**LEBANON PLANNING BOARD
AUGUST 12, 2024 - 6:30 PM
COUNCIL CHAMBERS, CITY HALL OR
REMOTE VIA VIRTUAL PLATFORM
LEBANONNH.GOV/LIVE**

- A. **Brickyard One Nominee Trust, 174 Hanover Street (Tax Map 48, Lot 4), 0 Hanover Street (Tax Map 48, Lot 2), 0 Hanover Street (Tax Map 48, Lot 1), and 238 Hanover Street (Tax Map 63, Lot 1), zoned R-1, R-O-1, R-3 & RL-3:** Request for Site Plan Review and a Conditional Use Permit pursuant to Sections 308.2, 310.2, 311A.2, and 501.2 of the Zoning Ordinance for a proposed 474-unit multi-family Planned Unit Residential Development (PURD) totaling +/- 731,600 sq. ft. in size, consisting of 11 buildings together with parking, utilities, landscaping, access, and other related site improvements. Applicant also requests a Conditional Use Permit pursuant to Section 308.4 of the Zoning Ordinance to allow an increase in the maximum permitted building height from 45 ft. to 55 ft. **PB2024-22-CUPSPR - Continued from July 8, 2024**

**RE: July 8, 2024 Planning Board Meeting - Agenda Item 4.A
Marlee Dixon/Greg Hagley Appeal of Impact Fee Assessment -
78 Bank Street (Tax Map 92, Lot 106), Zoned R-O**

C4.3

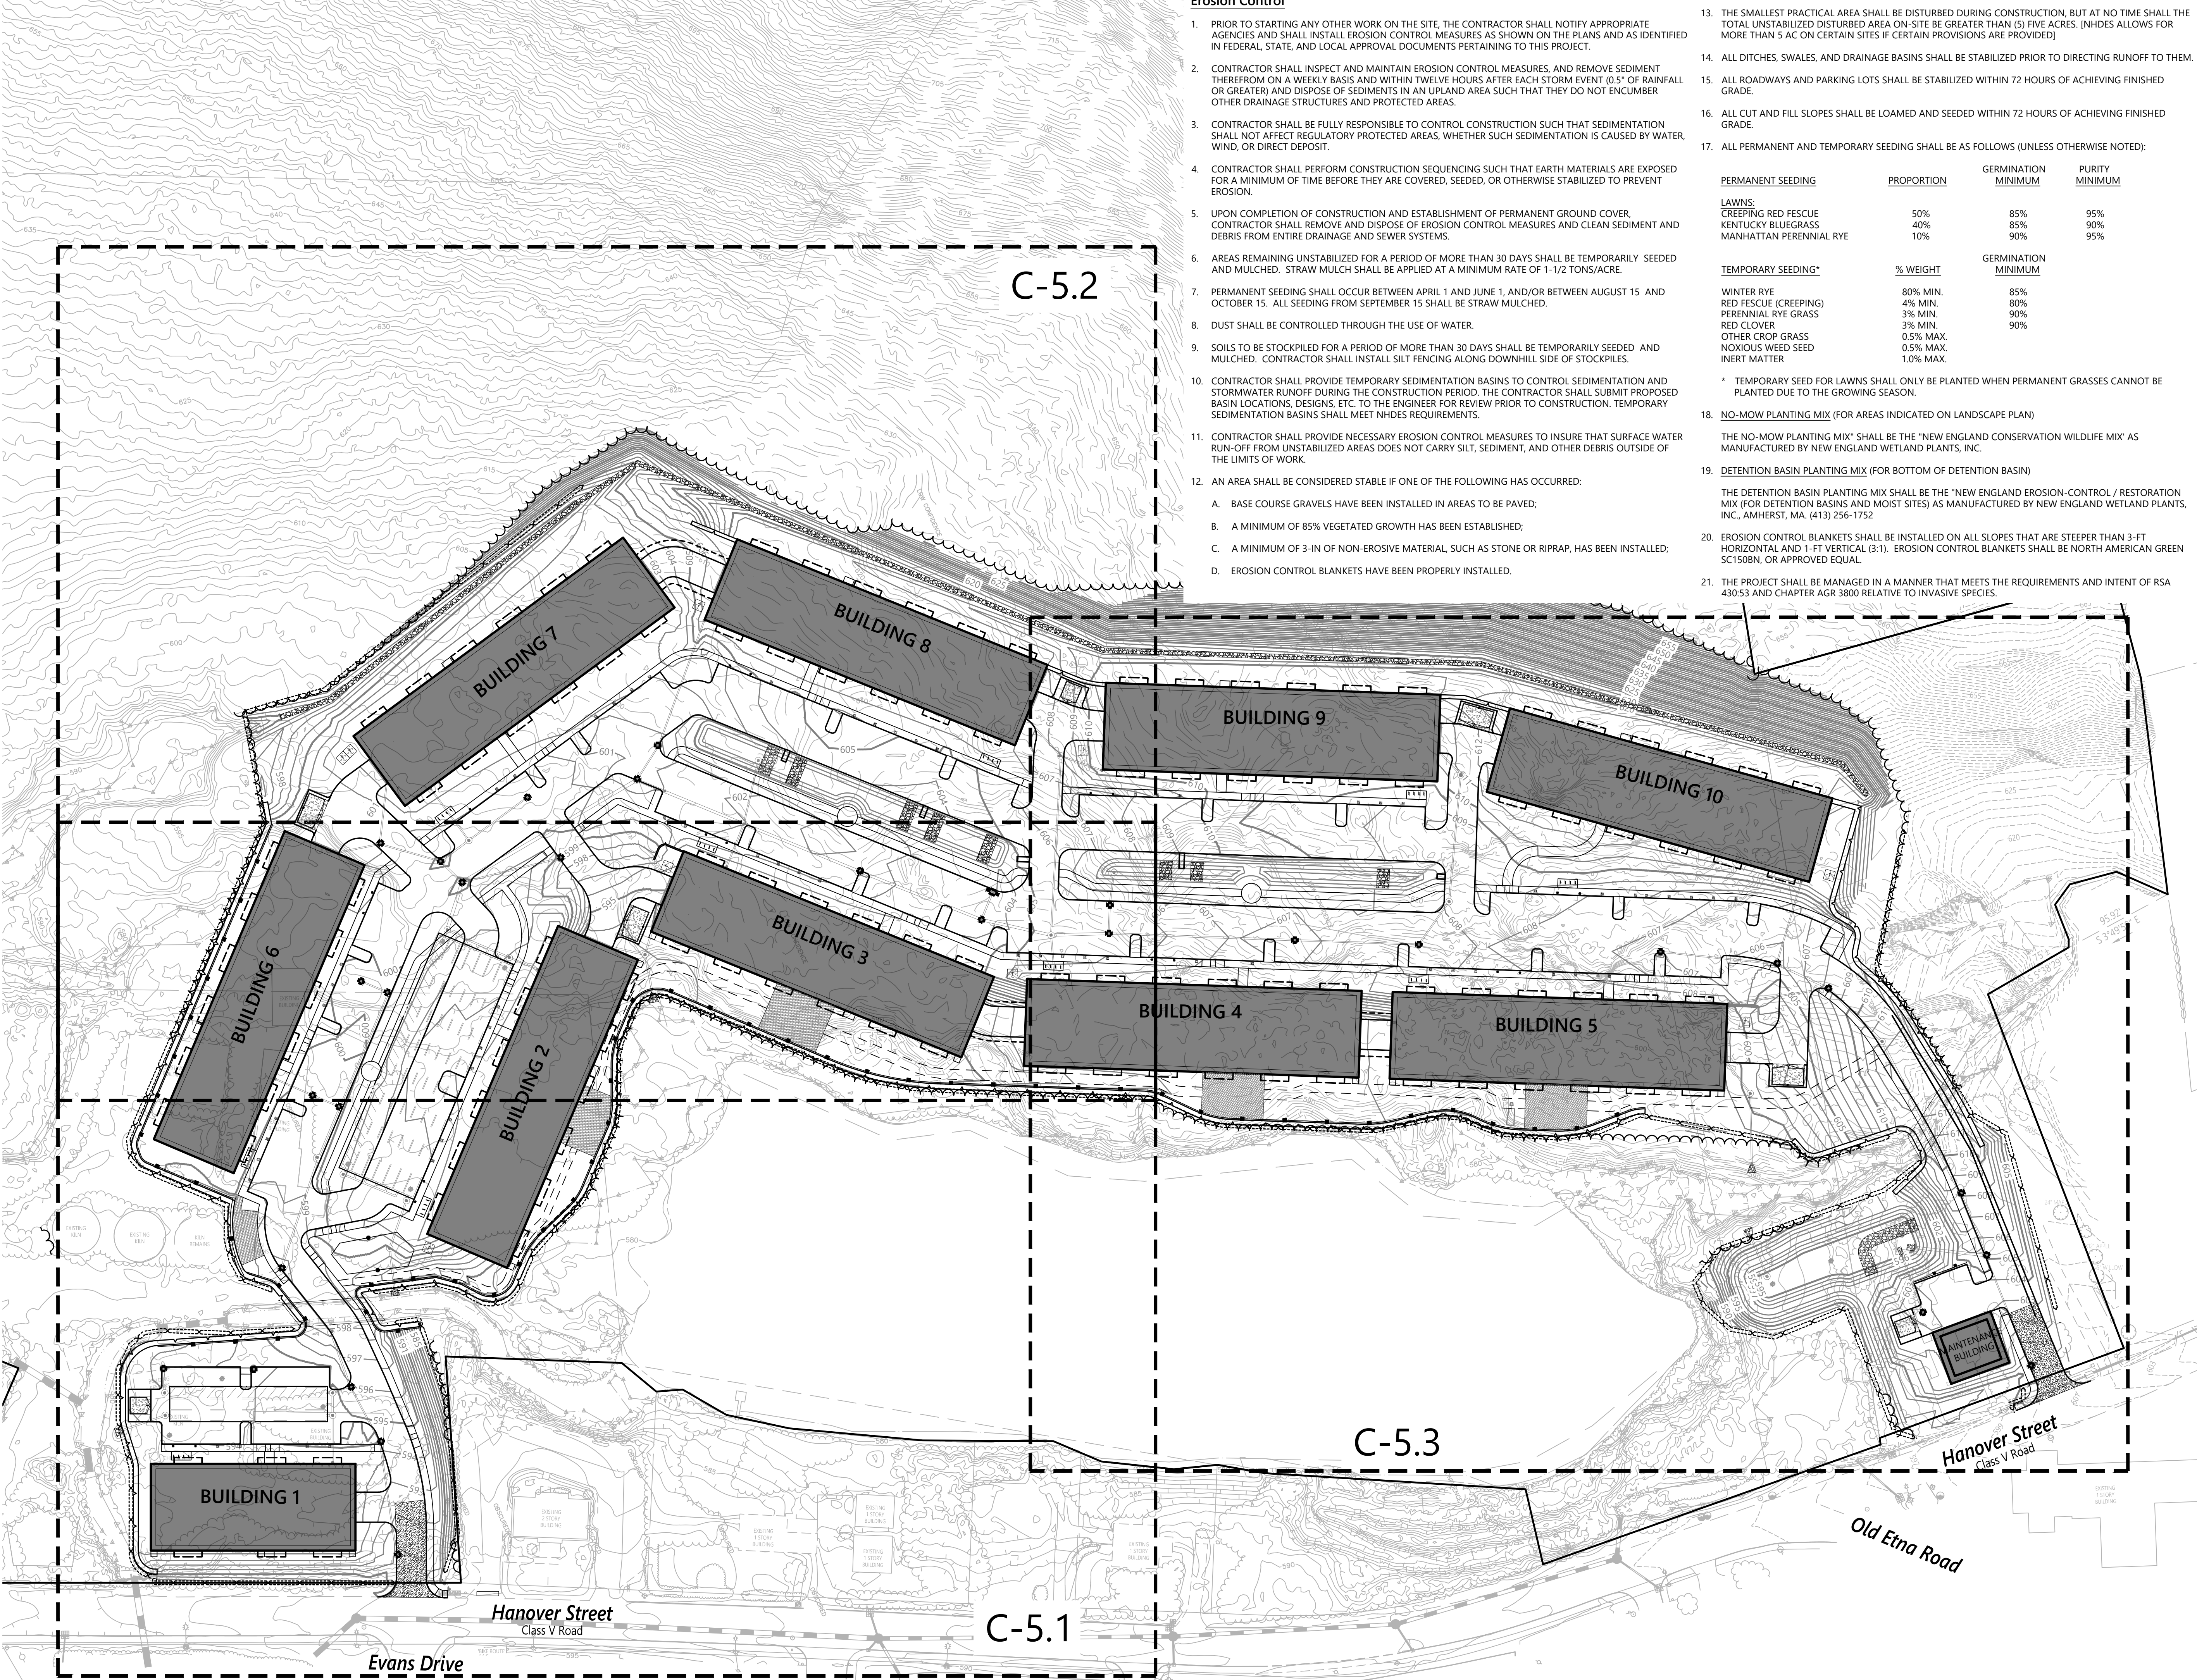
- Sheet C4.3 graphically depicts a series of four segments of storm drain discharging to daylight. We recommend expansion of the drawing to specify: (a) end treatment; (b) invert elevation; and (c) accommodation for outlet protection at each location.

22. As shown on Sheet C4.3, a 4-way junction of water main/service is planned at Buildings 5 and 10. For improved serviceability and ease of construction, we recommend off-setting these two services so connections to the main can be constructed as two successive 3-way junctions.

- We recommend expansion of Sheet C4.3 to specify pipe diameter, slope, and length values for two segments of proposed sewer connecting the planned maintenance building with SMH 201. We offer an identical comment for Buildings 3, 4 and 7.

Sv-2

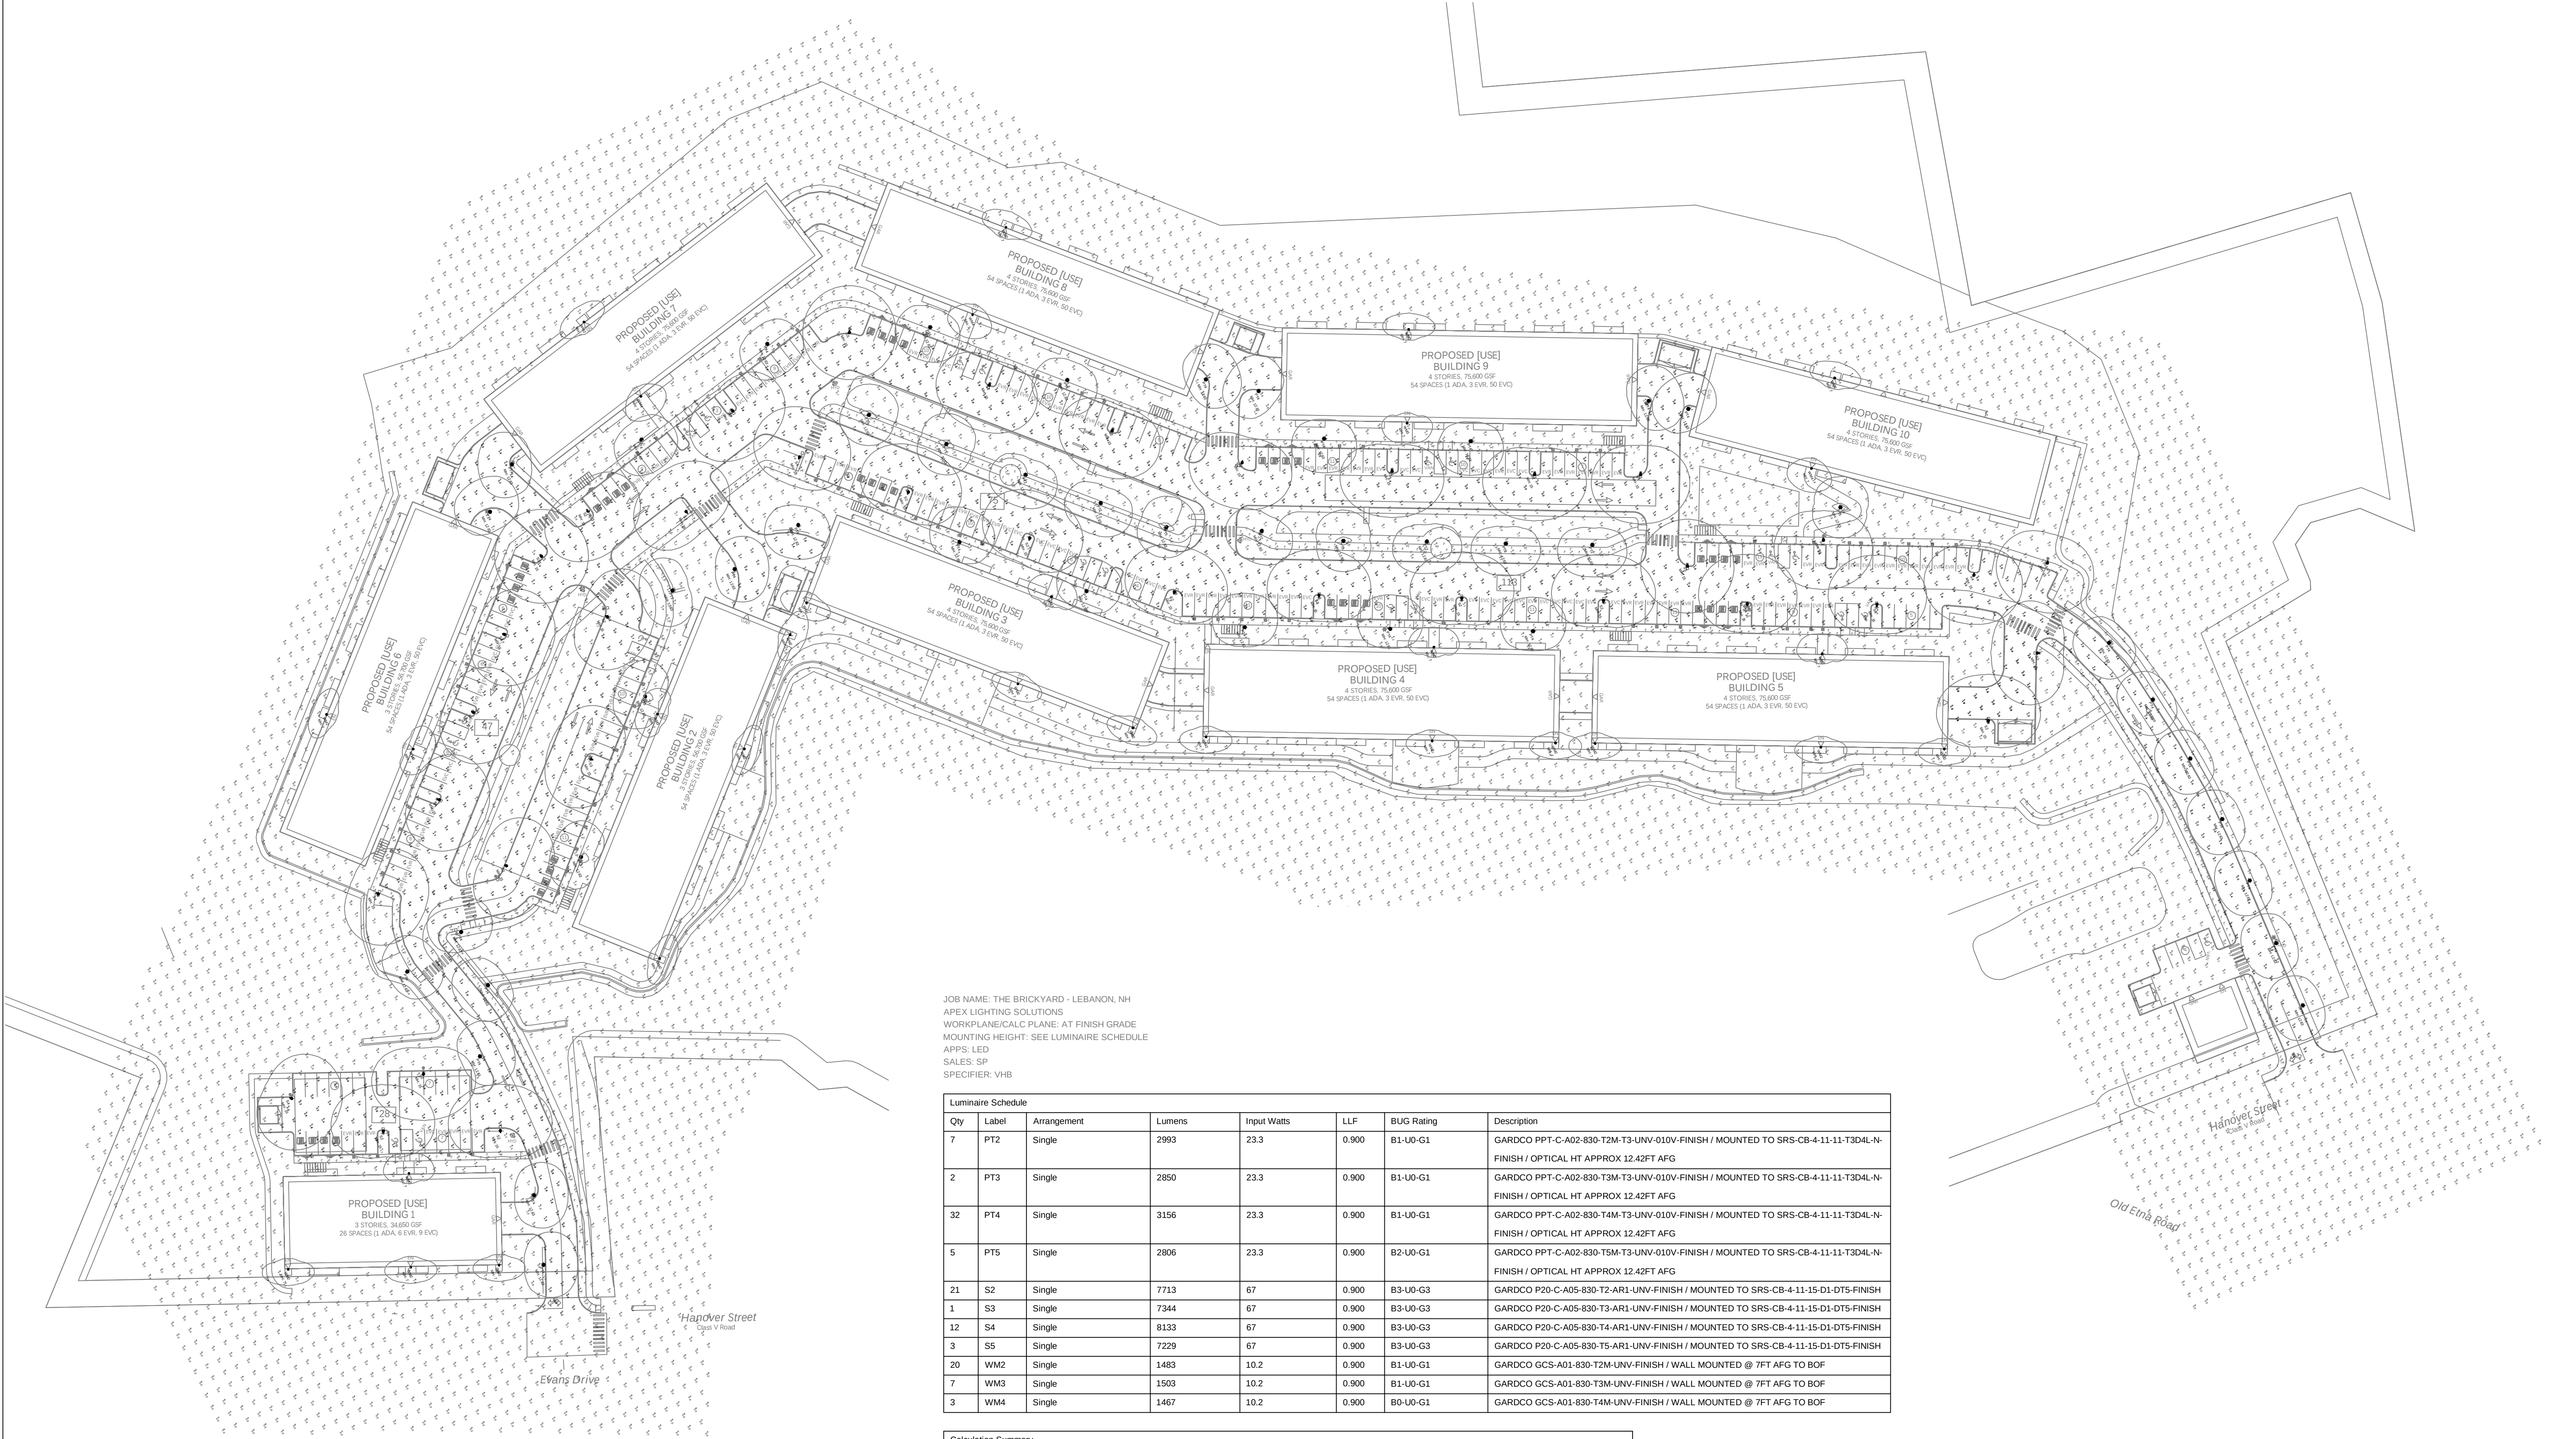
- We recommend the drawing identify the intended disposition of two existing 60-inch diameter and one existing 54-inch diameter culverts located in the vicinity of Building 1 (See Sheets Sv-2 & C4.1).

Response: Existing kilns and other existing features are shown in greater detail and with more clarity on sheets SV-2 and SV-3 than SV-1. Plan readability has been improved to the extent practicable.
